SERVICE Counselor

PACKARD DIVISION
OF
STUDEBAKER-PACKARD CORPORATION

SEPTEMBER, 1955

Fig. 1

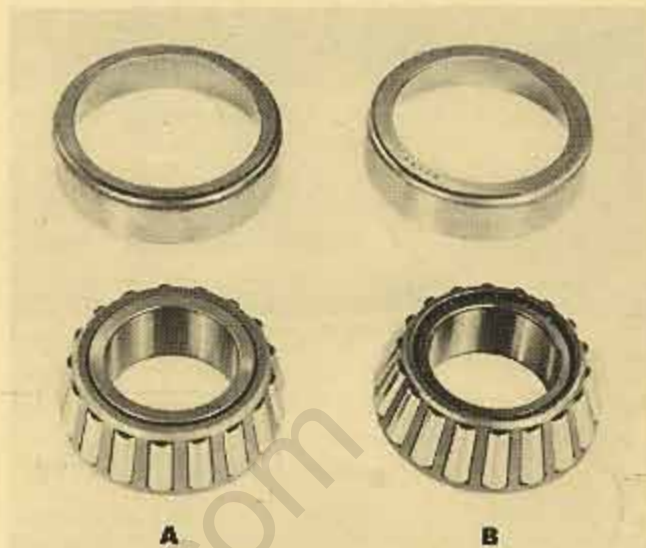
Some of the last run of 55th Series production will be equipped with 25° rear pinion bearings and when the present stock of 40° rear bearings are exhausted

at the Central Warehouse, Part No. 434855 (25° bearings) will be shipped for service replacement. When ordering Part No. 434855 Rear Pinion Bearing also order Part No. 434856 Pinion Bearing Sleeve.

Figure 1, indicated by "A", shows the 25° rear pinion bearing and cups. The 40° rear pinion bearing is indicated by "B". Note the difference in the angle of the rollers, also that the flat end section is wider on the 40° bearing cup.

It is permissible to use either the 25° or 40° rear pinion bearings provided the proper sleeve is also used. The sleeves are slightly different in length, therefore it is important that the correct sleeve be used so as to obtain the proper preload on the pinion bearings.

Fig. 2

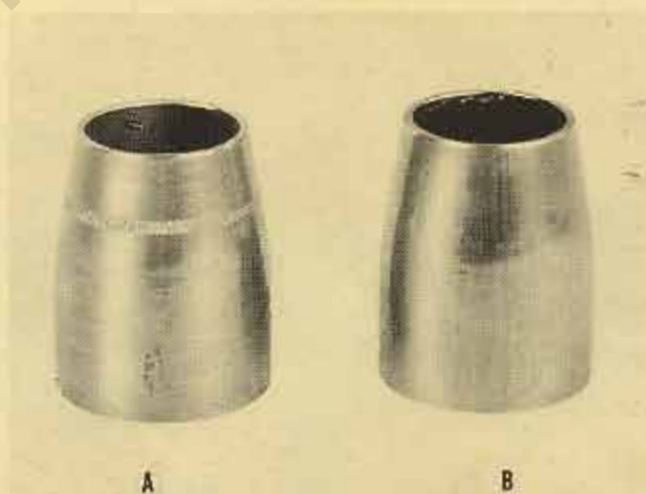
Figure 2, indicated by "A" shows the pinion bearing sleeve used with the 25° bearing. The sleeve used with the 40° bearing is indicated by "B". The knurled section on the 25° bearing sleeve (A) is provided for identification purposes.
